Access Compliance Report

Public Rights-of-Way

(Curb Ramps)

Intersection ID: 22096	Main Street: COLONY_RD	Cross Street: CARMEL_CRESCENT_DR	Location: NW
ADA ID: 4F7CAE60BD45	Ramp Type: PerpDiag	Initial Pass/Fail: Fail	Overall Compliance: No
		Severity Score: 25

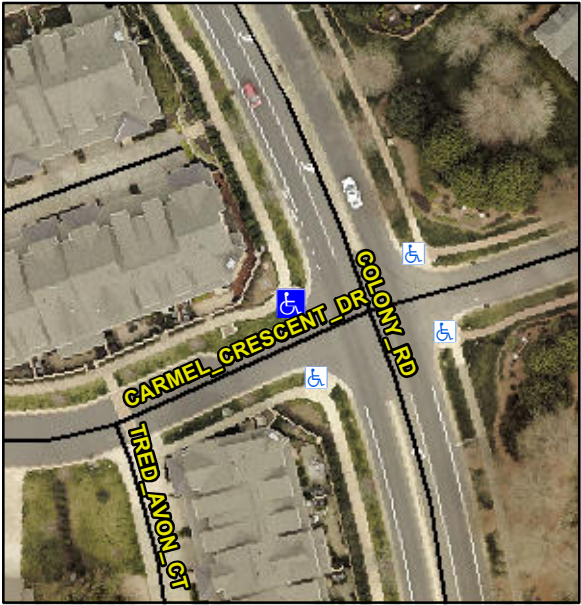
Codes/Mitigation Info/Possible Solution			Field Measurements/Component Compliance		
	Possible Solutions:		Compliance	Description	Data
	Remove & Replace Curb Ramp With Two New Directional Ramps or Equivalent.		N/A	Ramp Length (in)	95.0
			Yes	Ramp Width (in)	48.0
			N/A	Flare Type LT	N/A
			N/A	Flare Slope LT (%)	N/A
			N/A	Flare Traversable LT?	N/A
			N/A	Landing Length (in)	N/A
			N/A	Landing Width (in)	N/A
			N/A	Landing Slope (%)	N/A
			N/A	Landing X Slope (%)	N/A
<p>Surveyor Notes:</p> <p>N/A</p> <p>PROW/ADA:</p> <p>Not Found, R304.2.2, R304.5.3</p>			N/A	Flare Type RT	N/A
			N/A	Flare Slope RT (%)	N/A
			N/A	Flare Traversable RT?	N/A
			N/A	DWS Provided?	N/A
			N/A	DWS Contrast?	N/A
			N/A	DWS Length (in)	N/A
			N/A	DWS Full Width?	N/A
			N/A	DWS Offset (in)	N/A
			N/A	Shared Landing?	N/A
			N/A	Gutter Ponding?	N/A
			N/A	Gutter Lip Ht (in)	N/A
			N/A	Painted X Walk1?	No
				X Walk 1 Direction	To S
			N/A	X Walk 1 Width (in)	N/A

X Walk 1 Slope (%)	2.0
				X Walk 1 X Slope (%)	4.7
			N/A	Ramp inside XWalk1?	N/A
				Road Slope (%)	2.0
				Road X Slope (%)	2.8
			N/A	Any Obstructions?	N/A
				Obstruction Type	
Total Cost:		\$ 3200.00			
			N/A		N/A
			Yes	Surface Condition? (G/P)	Good
